RE: C.G.S. 8-24 Referral – Planning & Zoning
Sewer Main Extension – 19 Cannon Rd

**GENERAL STATUTES § 7-246a APPLICATION OF
BAYWING L.L.C. FOR SEWER EXTENSION,
ALLOCATION OF
SEWER CAPACITY, AND APPROVAL TO CONNECT A
MULTI-FAMILY DEVELOPMENT
AT 19 CANNON ROAD, WILTON**

Re: Application of Baywing L.L.C. for Approval to Sewer Extension, Capacity Allocation, and Sewer Connection, 19 Cannon Road, Wilton

Sanitary Sewer Plan and Profile

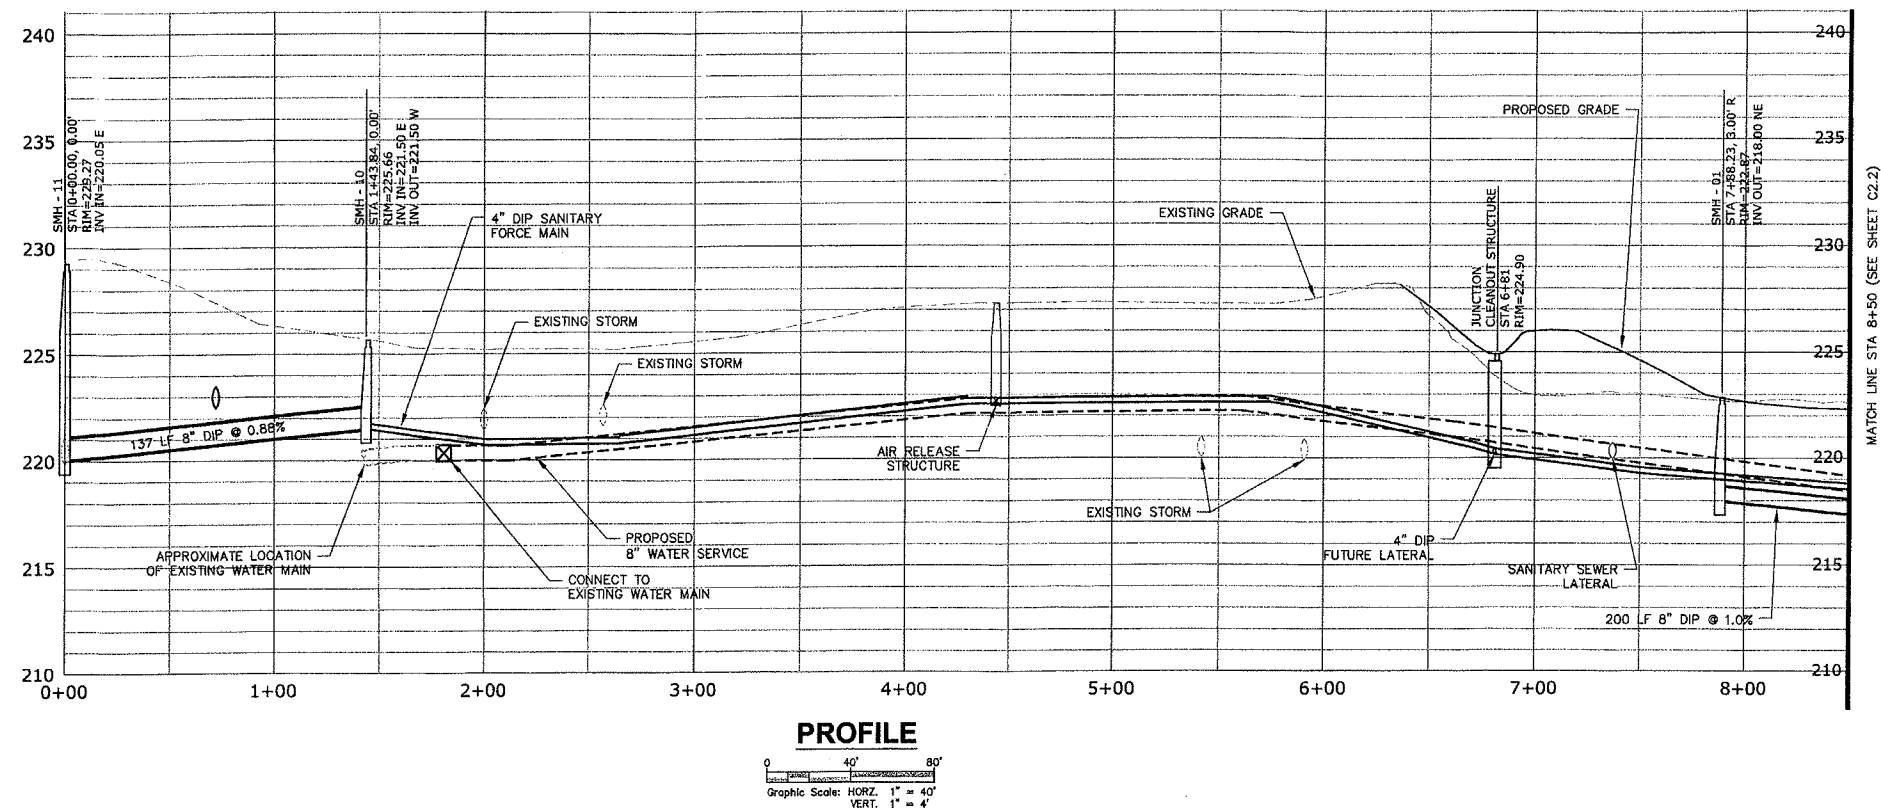
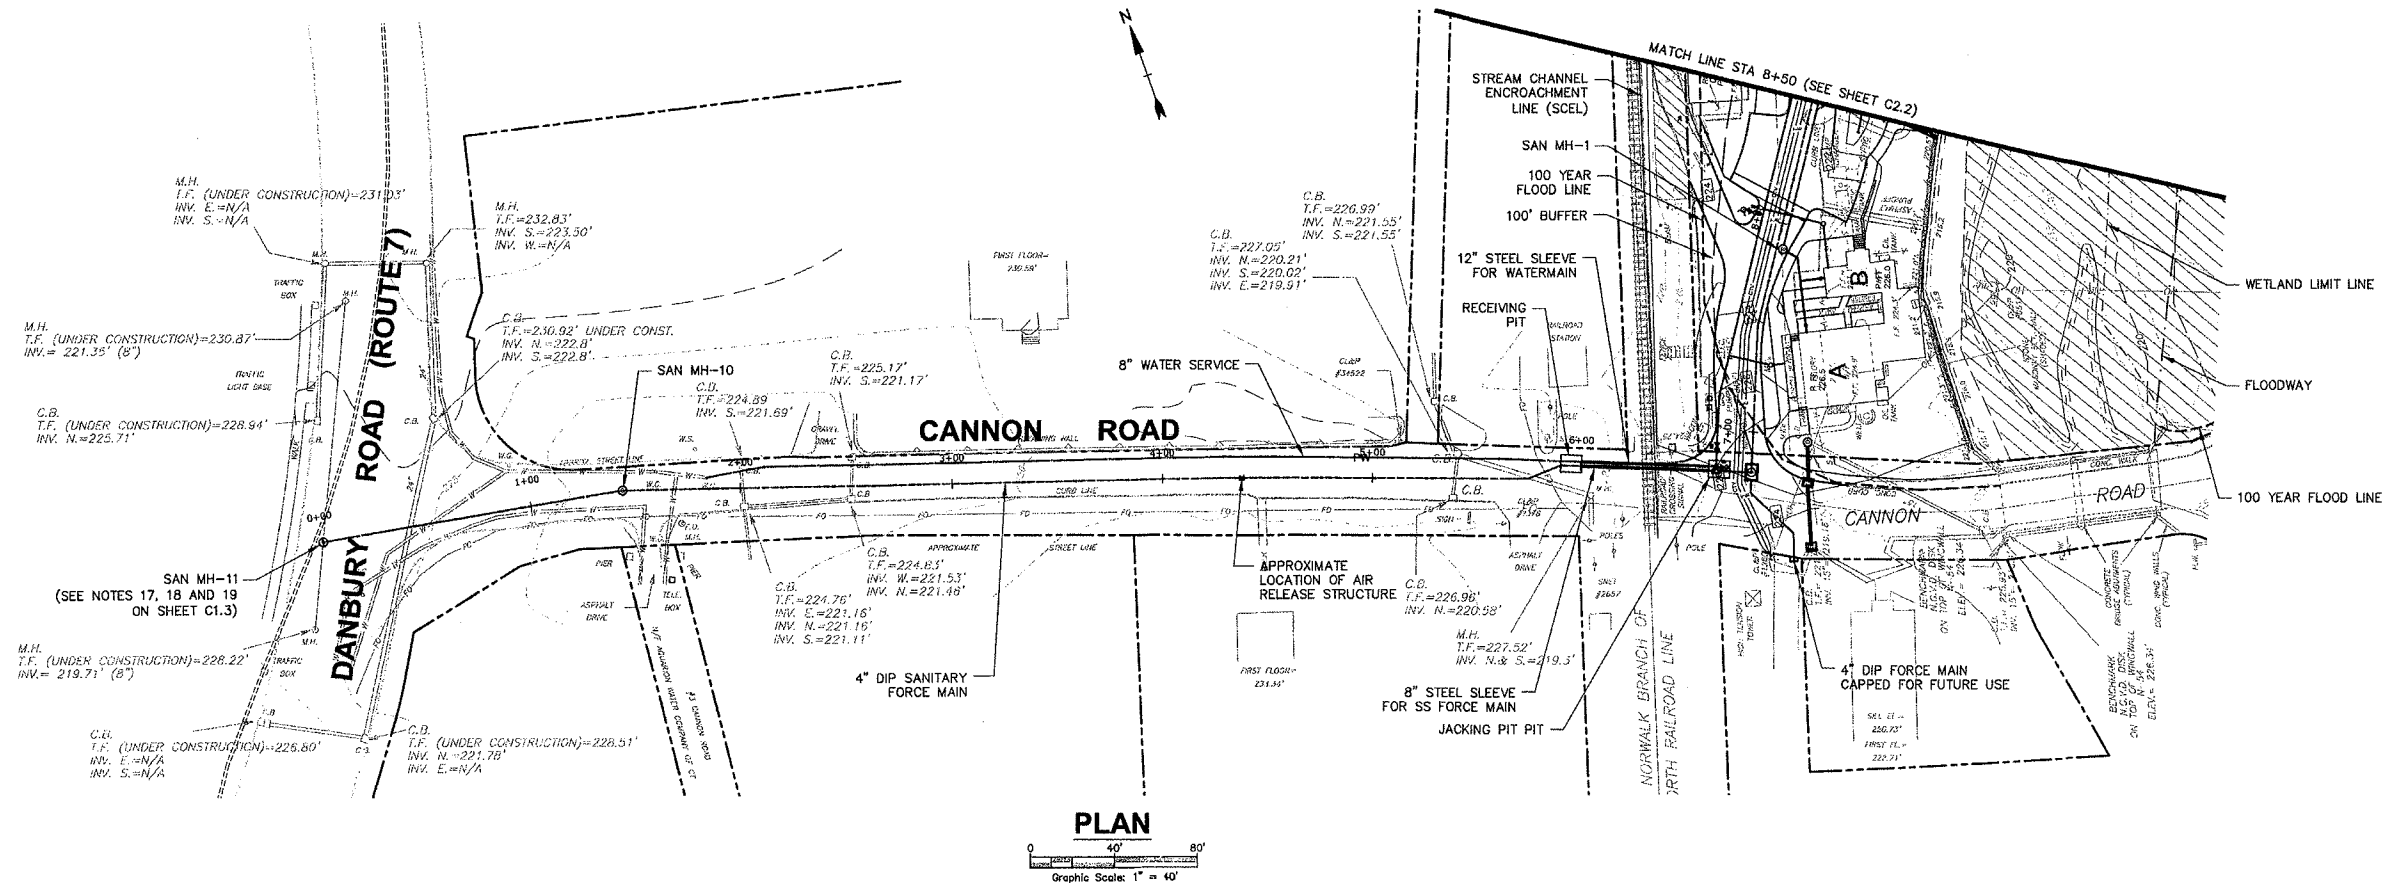
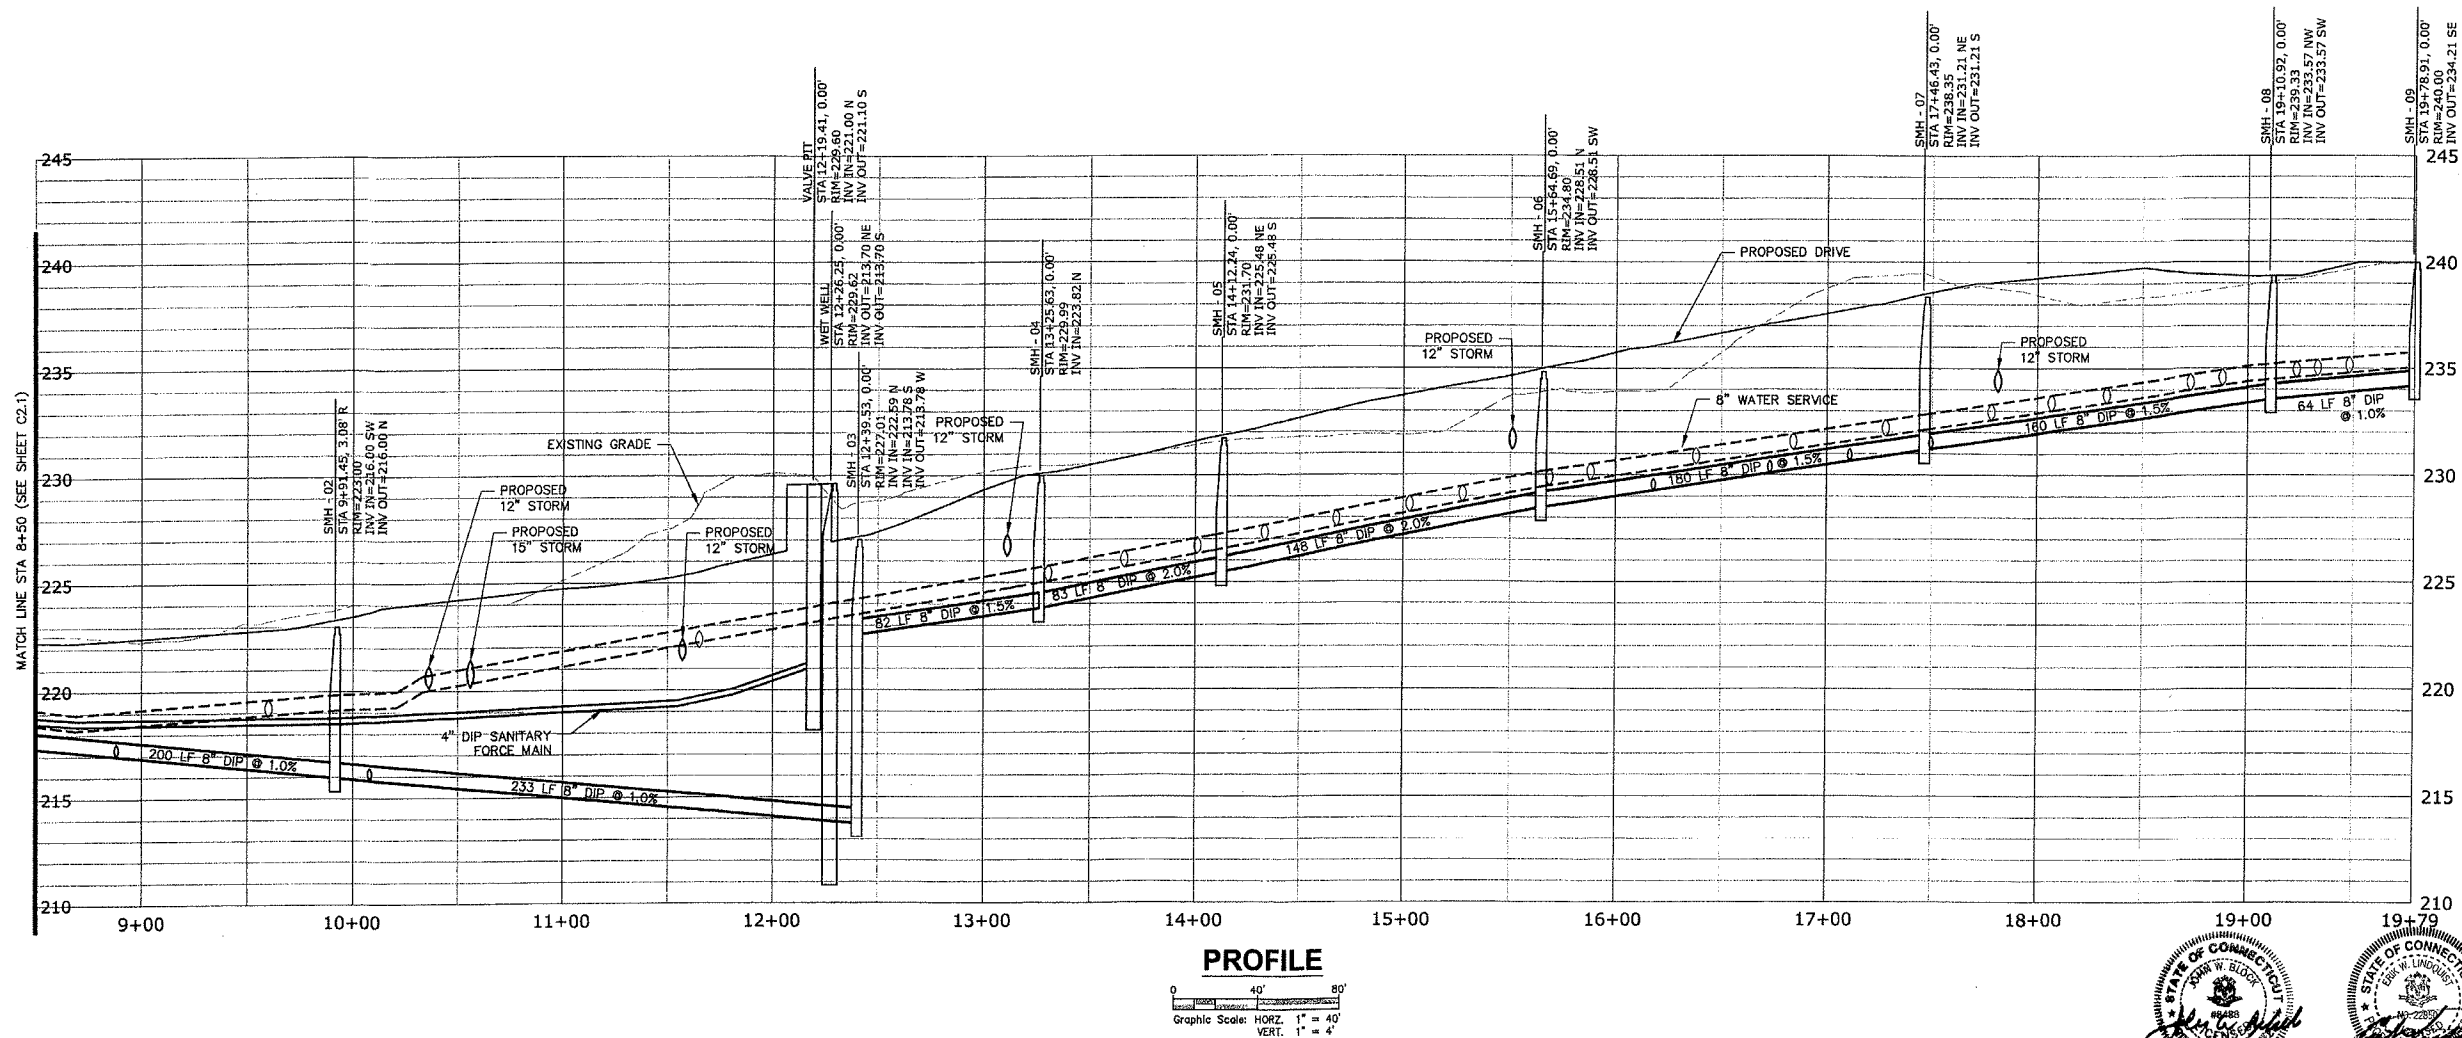
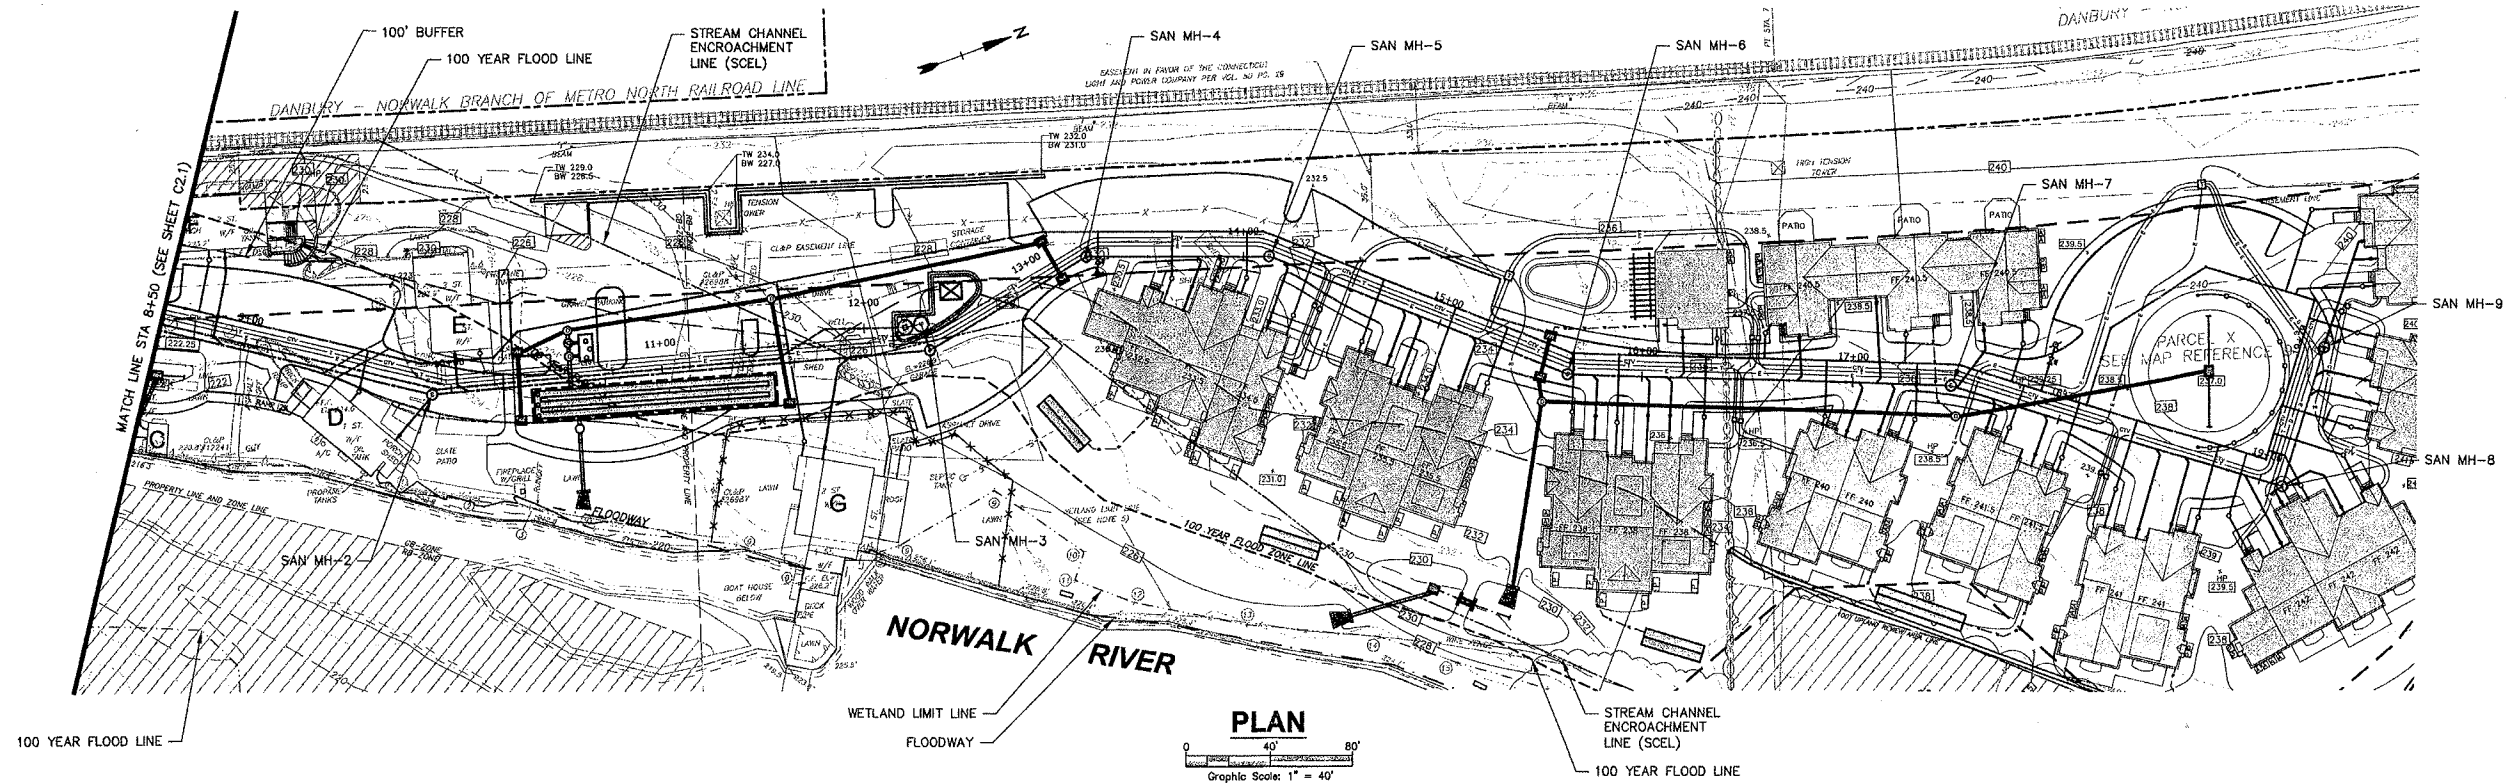
11. *Need valves added at connections just east of RR, with MHs for access. Confirm that terminal cleanout structure will be large enough to fit assembly.*

12. Add air release valve(s).

RESPONSE: A junction cleanout structure has been added just east of the railroad to accommodate the 4-inch valve for the Grange and the 4-inch valve for the proposed site. The terminal cleanout structure has been eliminated in favor of the junction cleanout structure and it will be adequate to accommodate the required fittings and appurtenances proposed.

RESPONSE: We have added two air release valves to the plan sheets. The first valve is located in the valve vault, and the second is located approximately at station 4+30.
